# Access Compliance Report

## Public Rights-of-Way

### (Curb Ramps)

Intersection ID: 4014	Main Street: DAVIS_LAKE_PY	Cross Street: DOWNING_CREEK_DR	Location: W
ADA ID: E0C9889DAB74	Ramp Type: BlendTrans1	Initial Pass/Fail: Fail	Overall Compliance: No
		Severity Score: 60

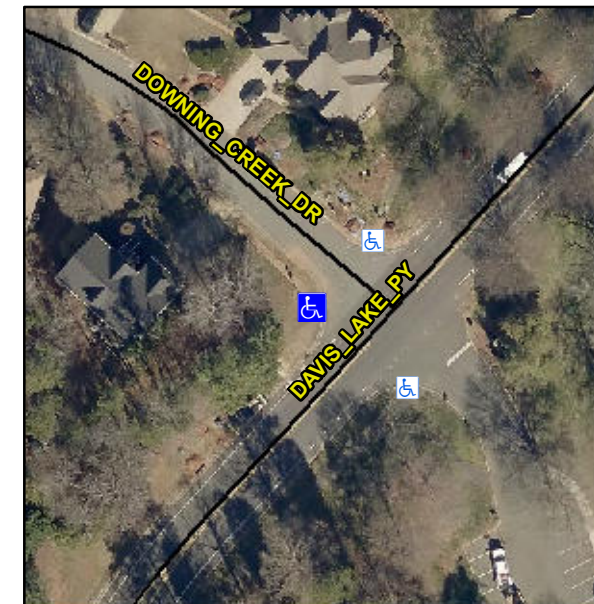
**Not Found, R304.5.1, R304.5.3**

Compliance	Description	Data	Compliance	Description	Data
N/A	Ramp Length (in)	50.0	Yes	BlendTrans Slope (%)	2.7
No	Ramp Width (in)	31.5	No	BlendTrans XSlope (%)	14.2
N/A	Flare Type LT	N/A	N/A	Flare Type RT	N/A
N/A	Flare Slope LT (%)	N/A	N/A	Flare Slope RT (%)	N/A
N/A	Flare Traversable LT?	N/A	N/A	Flare Traversable RT?	N/A
N/A	Landing Length (in)	N/A	N/A	DWS Provided?	N/A
N/A	Landing Width (in)	N/A	N/A	DWS Contrast?	N/A
N/A	Landing Slope (%)	N/A	N/A	DWS Length (in)	N/A
N/A	Landing X Slope (%)	N/A	N/A	DWS Full Width?	N/A
N/A	Landing Curb? (Y/N)	N/A	N/A	DWS Offset (in)	N/A
N/A	Shared Landing?	N/A			
N/A	Gutter Ponding?	N/A	N/A	Gutter Slope (%)	N/A
N/A	Gutter Lip Ht (in)	1.0	N/A	Gutter X Slope (%)	N/A
N/A	Painted X Walk1?	No	N/A	Painted X Walk2?	No
	X Walk 1 Direction	To SE		X Walk 2 Direction	To NE
	X Walk 1 Width (in)	N/A		X Walk 2 Width (in)	N/A
	X Walk 1 Slope (%)	5.0		X Walk 2 Slope (%)	4.7
	X Walk 1 X Slope (%)	8.6		X Walk 2 X Slope (%)	5.6

**Remove & Replace Curb Ramp With Two New Directional Ramps or Equivalent.**
